SILVER MOUNTAIN PUMP STATION IMPROVEMENTS PROJECT

Job No.: 19-6008

ADDENDUM 4

February 24, 2021

DRAWING NO.
E7

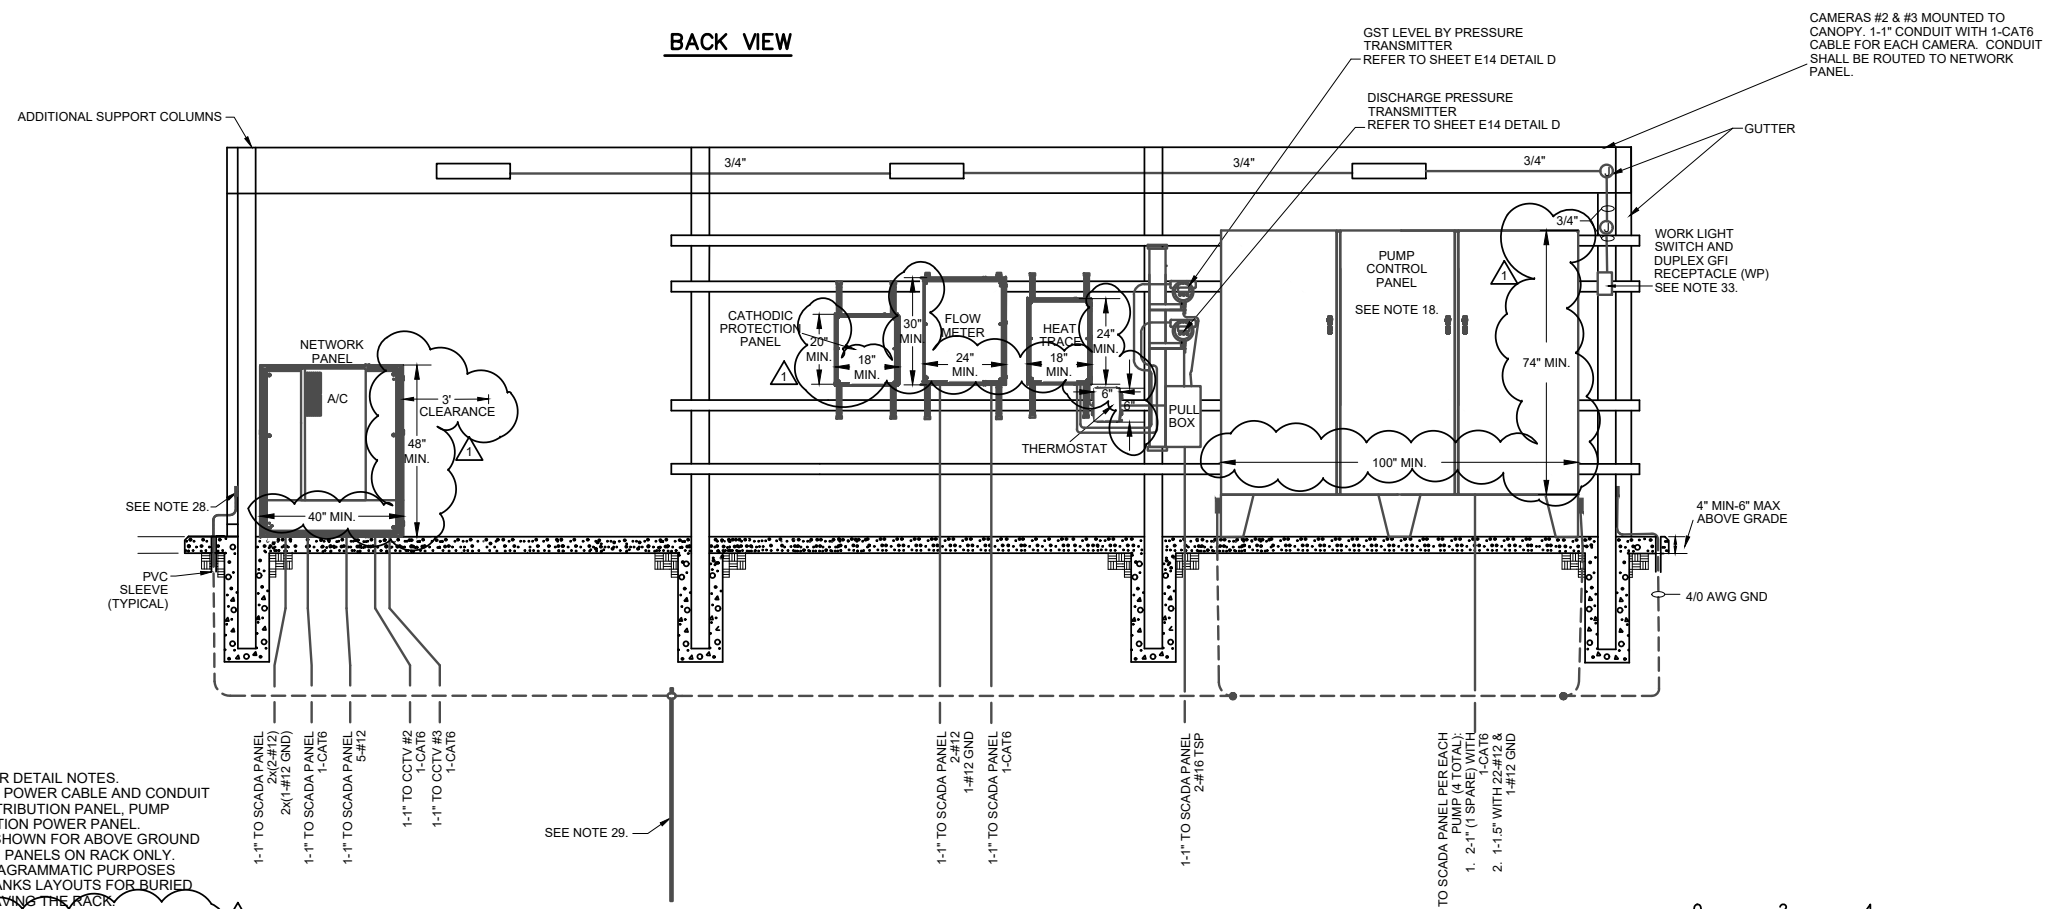
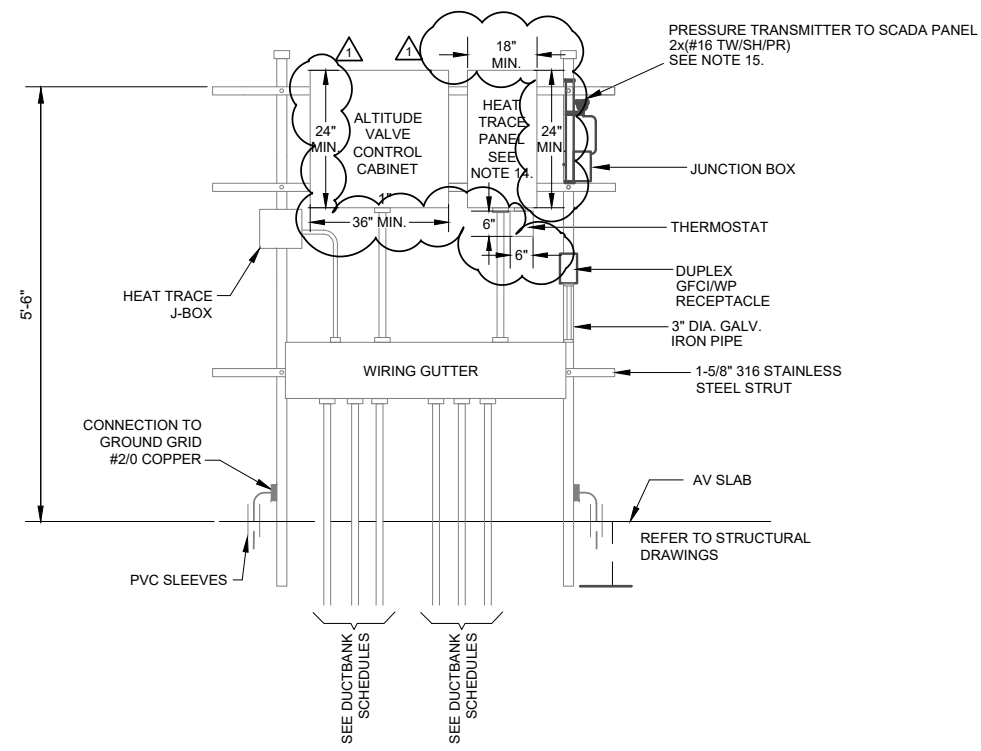
- 1. Question: On the control enclosures, there is no size listed. Please advise if you have that information and if so, we will need the room measurements. They are not on any documents.**

1. Sheet E7- Electrical Service Rack Layout- REMOVE and REPLACE Sheet E7 in its entirety.
2. Sheet E16- Miscellaneous Details #3 - REMOVE and REPLACE Sheet E16 in its entirety.
3. Sheet E17- Booster Pump Station Rack & Pump Control Panel Details - REMOVE and REPLACE Sheet E17 in its entirety.

Response: Per Section 16010-3.01.A.3, "Dimensions shown on the Drawings related to equipment are based on one typical manufacturer's equipment. Coordinate the dimensions of the equipment furnished with the space available." The enclosures shown on Sheet E7, E16, and E17 include minimum cabinet dimensions. Refer to Changes to the Plans Item 1, this addendum.
